S.S. PAPADOPULOS & ASSOCIATES, INC.
Environmental & Water-Resource Consultants

Date: September 19, 2019
From: Erica DiFilippo, Matt Tonkin, Christopher Neville, Xiaomin Wang (SSP&A)
To: Judy Canova and David Wilson (USEPA Region V)
Project: SSP-1453, Task 39
Subject: **Comments on 2004 Groundwater Modeling Report Prepared by Conestoga-Rovers & Associates (CRA)**

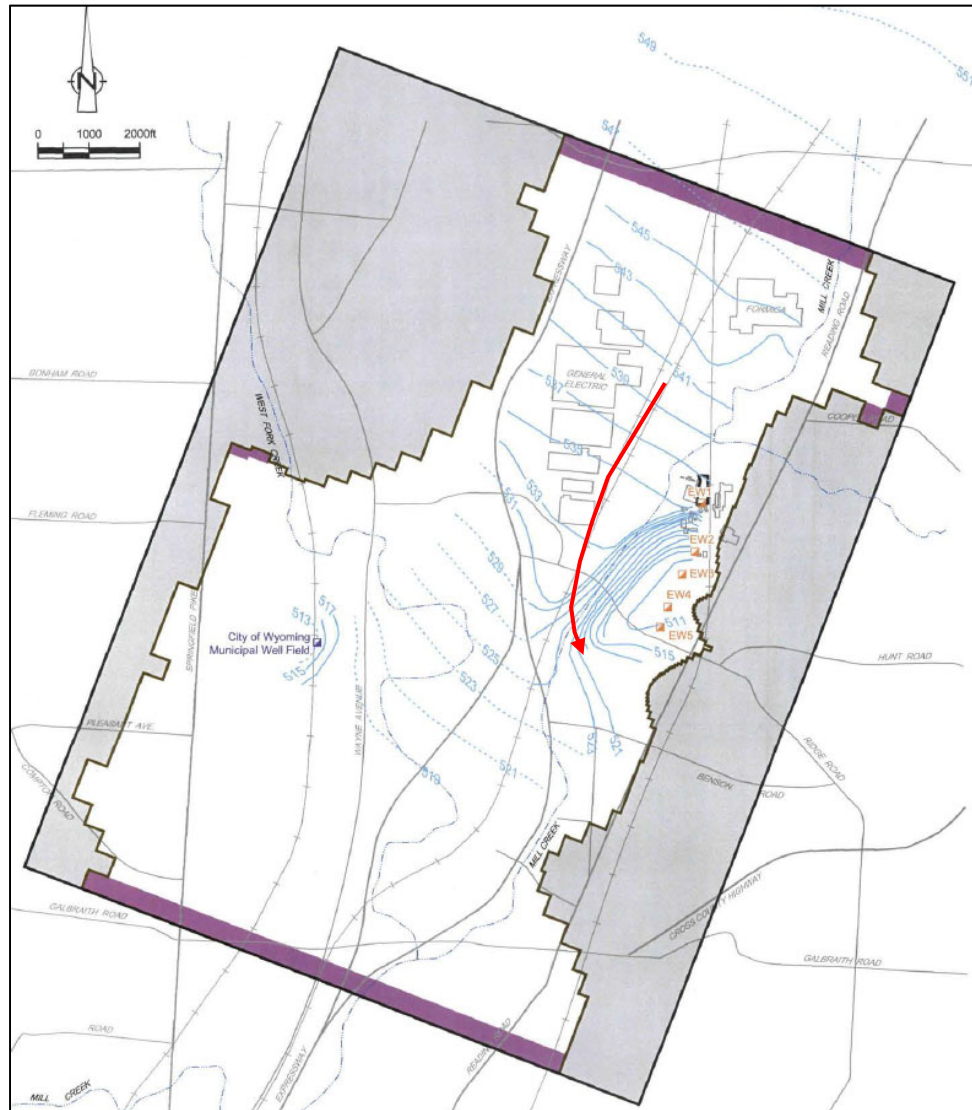
1. No regional-scale data were incorporated to constrain the elevation of the top of the LA. The elevations of the top of LA throughout the Site were interpreted using kriging and are shown in Figure 5.5 (reproduced below). Bulls-eye shapes in the contours can be observed which may be largely due to the distribution of data and strong contrasts in the elevations at neighboring locations. The data are sparse in the southern part of the model domain, particularly along the eastern and western sides of Mill Creek Valley. In contrast to other model surfaces (bedrock), no previous interpretations were incorporated to constrain the elevation of the top of the LA.

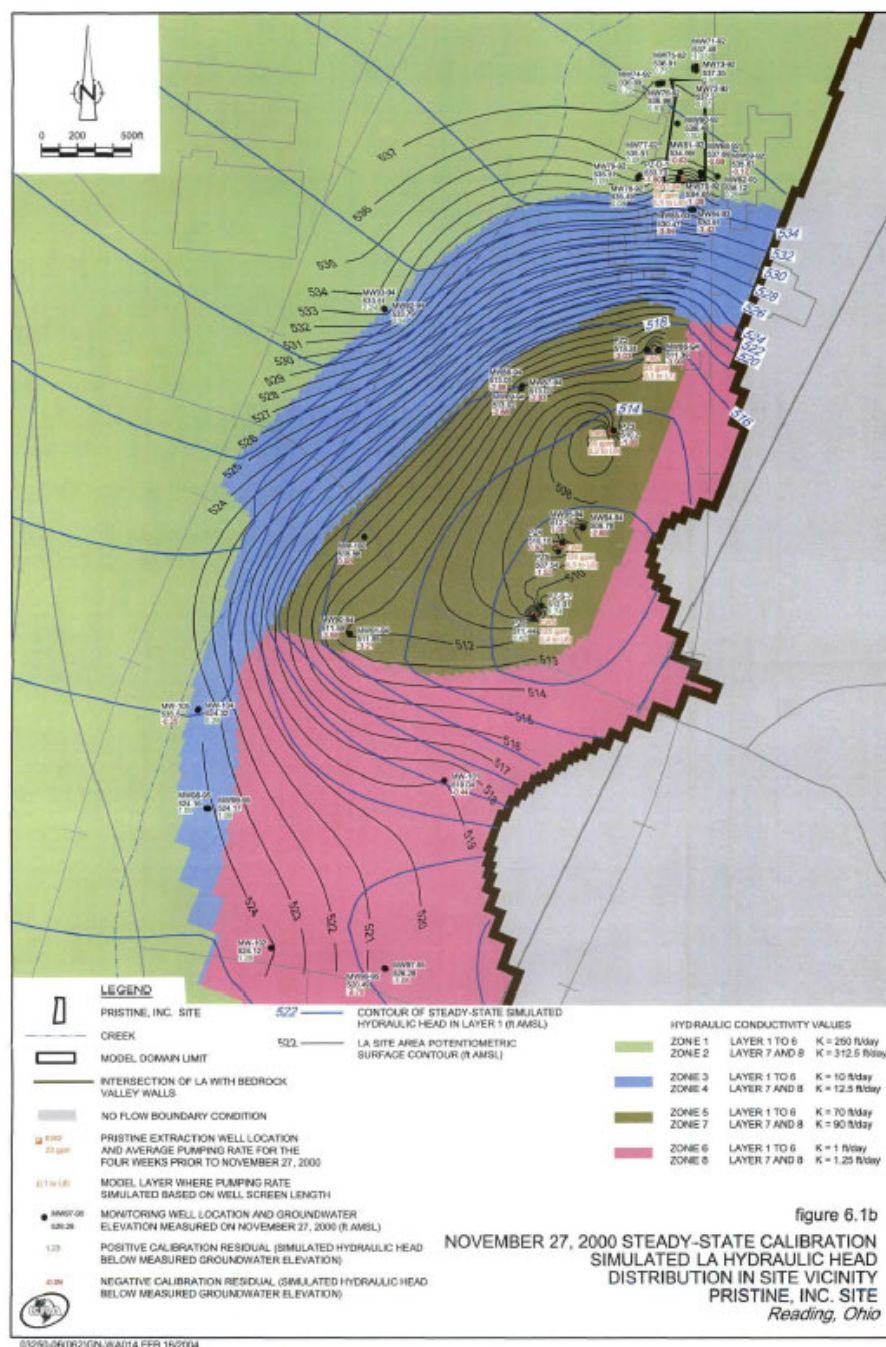
2. Mill Creek and the West Fork Creek are not represented in the 2004 model because they are assumed to impact the unconfined aquifer above the LA and not the LA directly (see General Comment #1). Mill Creek and the West Fork Creek should be simulated explicitly in the model, using the MODFLOW River or Drain packages for example, when the model is expanded to include the upper unconfined aquifer in the area of the Site. The potentiometric surface contours of November 2000 shown in Figure 3.1 by Schalk and

Schumann (2002)⁴ show evidence of water discharging to the Mill Creek following the red line in the figure below⁵.

⁵ The 2011 GE Aviation Site model does properly represent Mill Creek and the West Form Creek.

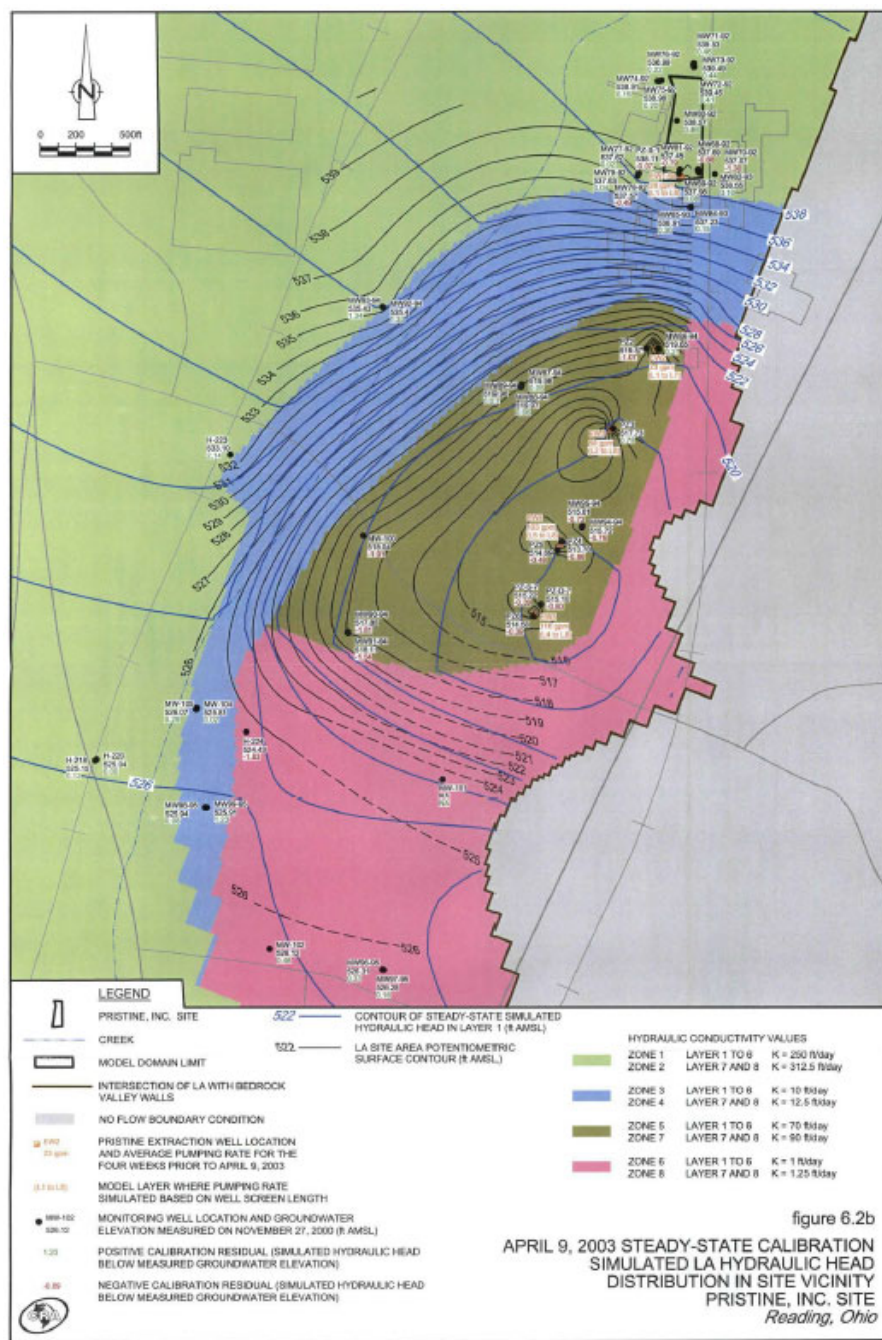
- The simulated water level contours from the steady-state simulation for November 27, 2000 are generally 1 ft lower than the interpreted LA potentiometric surface contours for that date [USGS WRIR 02-4167, Schalk and Schumann (2002)]. In addition, the cones of depression for the pumping wells EW3, EW4 and EW5 are very different from the interpreted water levels (Figure 6.1b: black contours denote interpreted groundwater levels, blue contours denote simulated groundwater levels). The 2004 model over-predicts the groundwater elevations around the well field in areas represented by hydraulic conductivity zones 5 & 7. In addition, the simulated hydraulic gradient is smaller than the observed by a factor of 2 to 3. These factors suggest that the hydraulic conductivity values assigned in zones 5 and 7 might be too large. A similar pattern can be observed in the water levels for the April 9, 2003 steady-state simulation (Figure 6.2b): simulated hydraulic gradients again appear smaller than the observed by a factor of about 2 to 3.

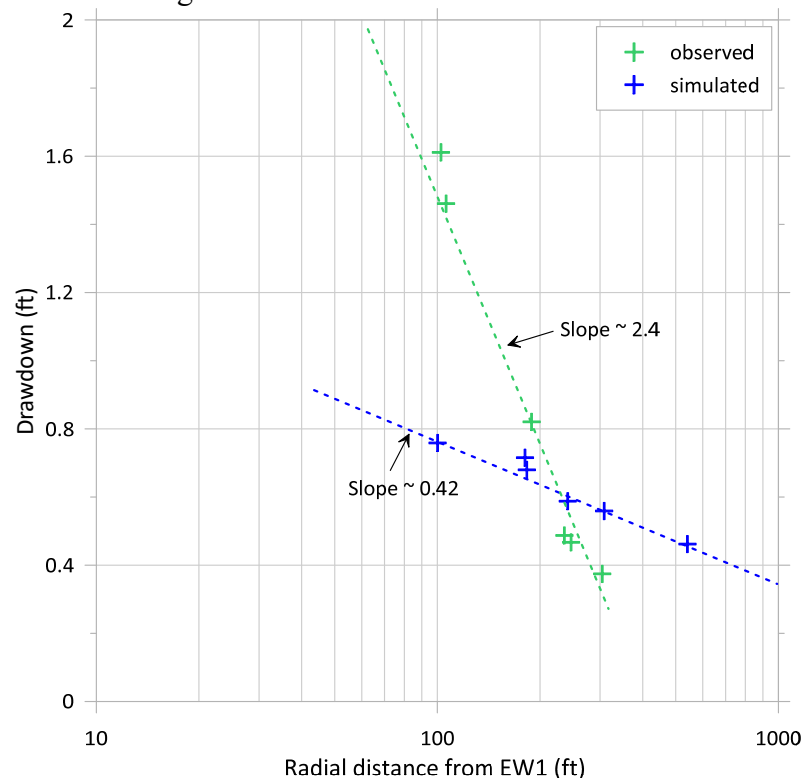
- f. The transmissivity specified in the numerical model is about 6 times higher than can be inferred from the drawdowns observed during the EW1 pumping test. The transient calibrated model for the EW1 72-hour pumping test shows reasonable agreement between simulated and observed drawdowns distant from the pumping well (Figure 6.5). The model under-predicts the drawdowns close to EW1 by approximately 0.8 ft. The distance-drawdown plot for the EW1 pumping test has been digitized and reproduced with semi-log axis (see figure below). The observations and the simulation results approximate two very different straight lines. The ratio of the slopes of the two lines is about 5.7, which suggests from Cooper-Jacob analyses that the transmissivity specified in the numerical model is about 6 times higher than is inferred from the observations. It is possible to obtain relatively good matches for the steady-state calibrations but have the transmissivity wrong by a factor of 6 by specifying constant-head boundaries in the model, as was done with the 2004 groundwater model.

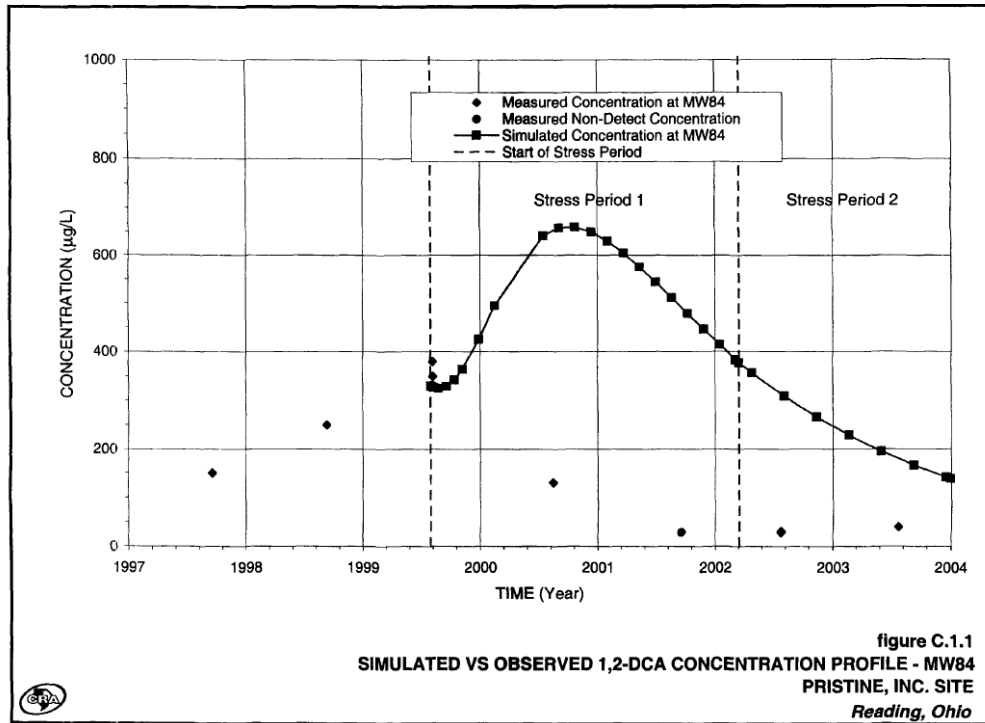
- g. At MW94, close to pumping well EW4 (within hydraulic conductivity zones 5 & 7), the transport model over-predicts concentrations, implying that the plume has not

been captured by the pumping well as soon as expected. This may be another line of evidence that the transmissivity around the well fields is too large.

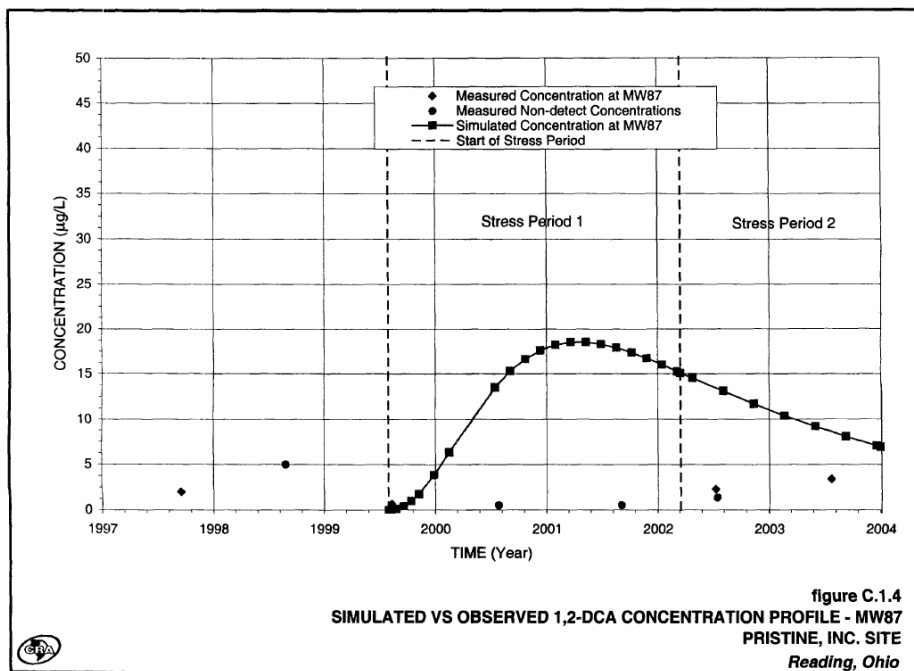
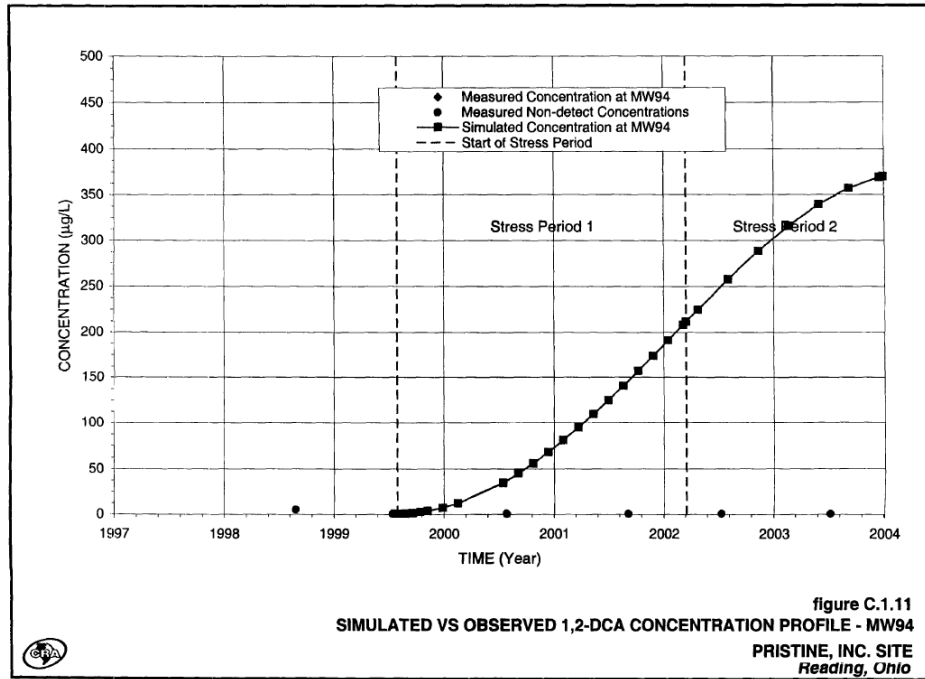
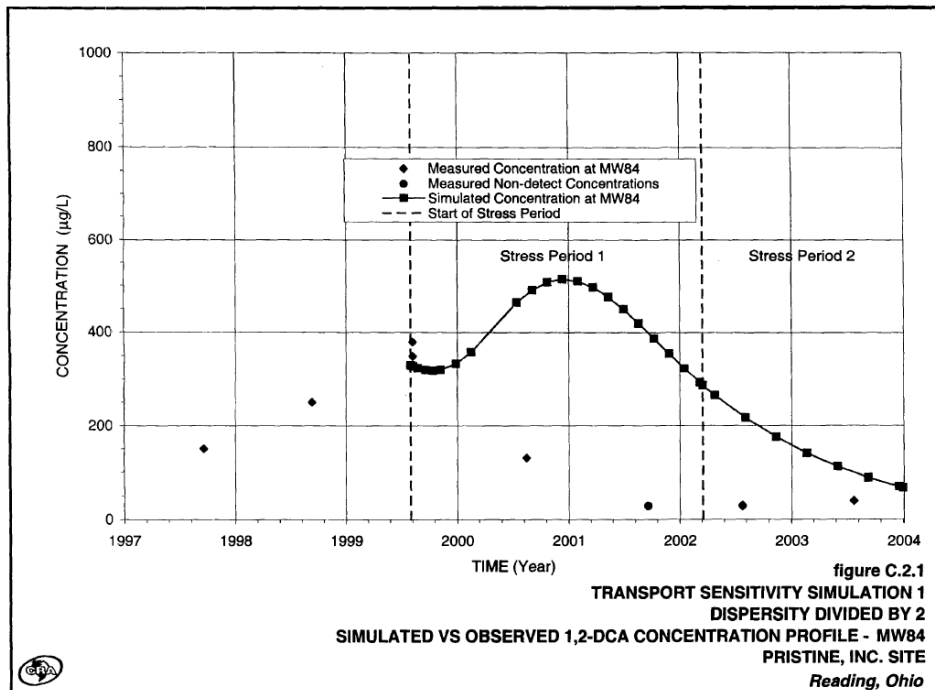
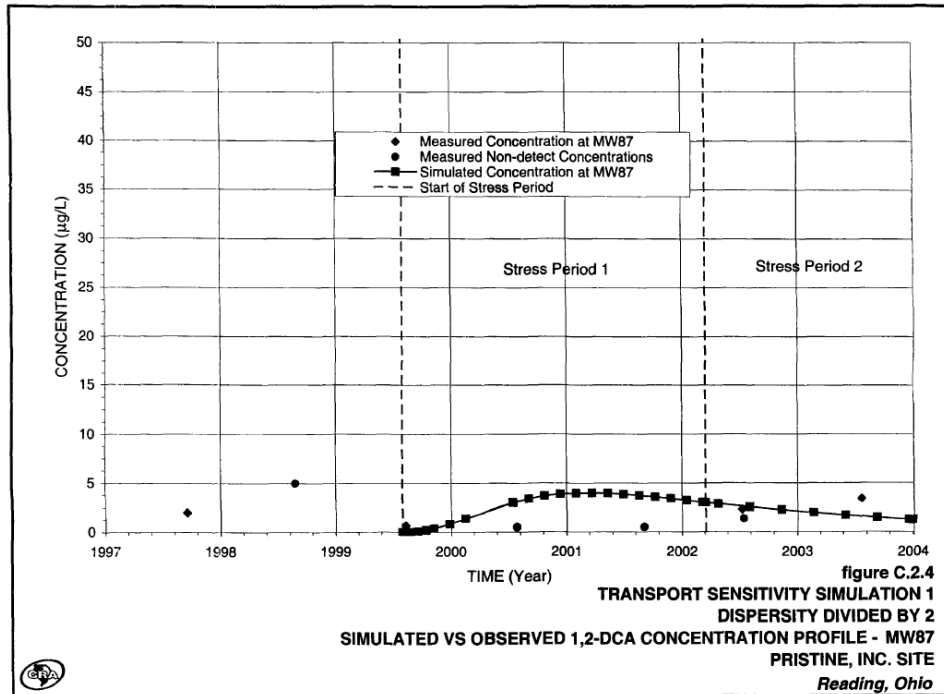
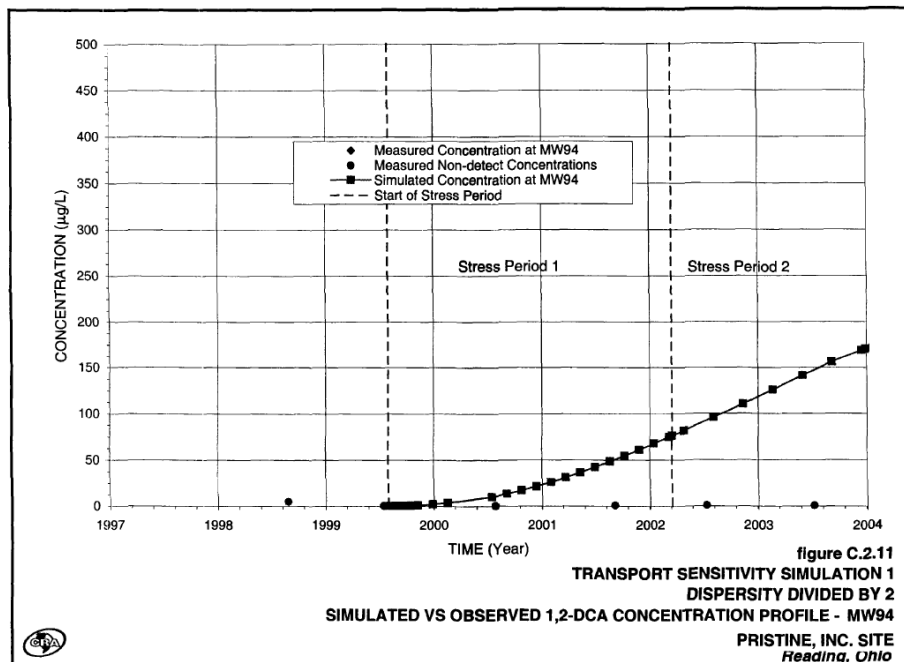
- b. The mismatch of transport simulation results to observations is particularly evident at locations outside the plume center such as MW84, MW87 and MW94. Sensitivity analyses were conducted on two parameters, longitudinal dispersivity and sorption coefficient. The results show that reducing the longitudinal dispersivity, α_L , to half (i.e., 21ft) improves the match considerably at wells where the initial match is relatively poor. Comparisons of the match between the initial transport simulation and the sensitivity analysis #1 at three monitoring locations, MW84, MW87 and MW94 are shown below. The trends are similar, but the simulated magnitudes of the concentrations are closer to those observed.
